# PHILCO

## CHANGES IN MODELS

Since Publication of Each Service Bulletin

Grouped under each model and arranged according to date . . . All current models included . . . Corrected to January 1, 1935

MODEL 118 Service Bulletin No. 194

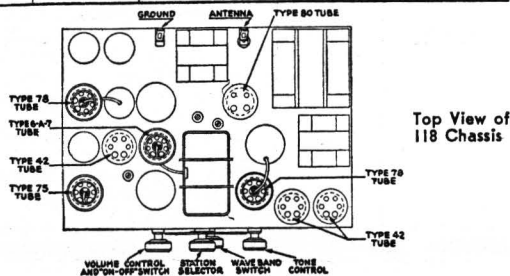
Corrections in Bulletin 194:  
Incorrect cut was used by printer for Fig. 2 of this bulletin. Correct illustration is shown herewith.

7-1-34	8	On Schematic (Fig. 2), arrow on Ⓞ should point to the nearby Compensating Condenser instead of the 1.0 mfd. Condenser section, which should be Ⓞ. Ⓞ should point to the .003 mfd. Mica Condenser. Also a connection should be made between the 6A7 Oscillator Plate and the lead from the Screen Grids of the two type 78 tubes. Following parts changed to facilitate wiring in production. Note that Resistors are not changed in value but in power rating only.
--------	---	--
